Project	<b>IEEE 802.16 Broadband Wireless Access Working Group</b> < <a href="http://ieee802.org/16">http://ieee802.org/16</a> >	
Title	<b>Restructuring and Renaming of Scanning and HO Primitives in section 14.2.9</b>	
Date Submitted	<b>2006-05-01</b>	
Source(s)	Jaesun Cha	<a href="mailto:jscha@etri.re.kr">jscha@etri.re.kr</a>
	ETRI	
	Ronald Mao	<a href="mailto:rmao@huawei.com">rmao@huawei.com</a>
	Huawei Technologies Co., Ltd.	
	Ronny (Yong-Ho) Kim	<a href="mailto:ronnykim@lge.com">ronnykim@lge.com</a>
	LG Electronics, Inc.	
Re:	Contribution on comments to IEEE 802.16g/D2	
Abstract	In this contribution, we propose to define some primitives for Neighbor BS Management.	
Purpose	Adoption	
Notice	This document has been prepared to assist IEEE 802.16. It is offered as a basis for discussion and is not binding on the contributing individual(s) or organization(s). The material in this document is subject to change in form and content after further study. The contributor(s) reserve(s) the right to add, amend or withdraw material contained herein.

# Restructuring and Renaming of Scanning and HO Primitives in section 14.2.9

Jaesun Cha, Ronald Mao, Ronny (Yong-Ho) Kim

**Figure 497 – HO Primitives flow between Serving BS and NCMS, BS initiated**

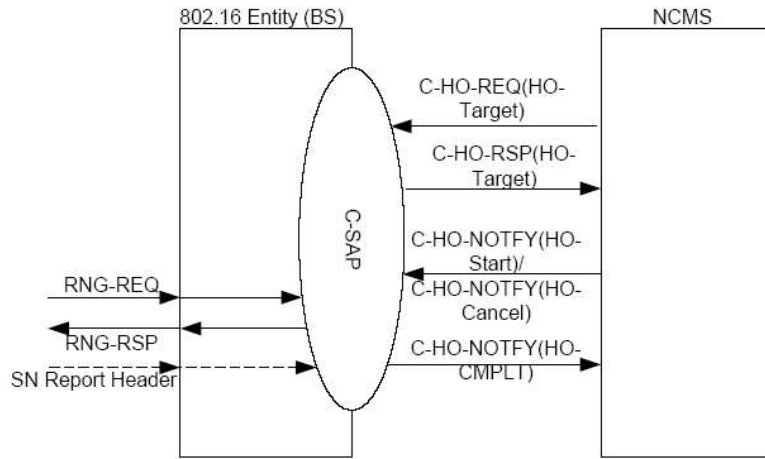
*[Modify section 14.2.7.2 as follow]*
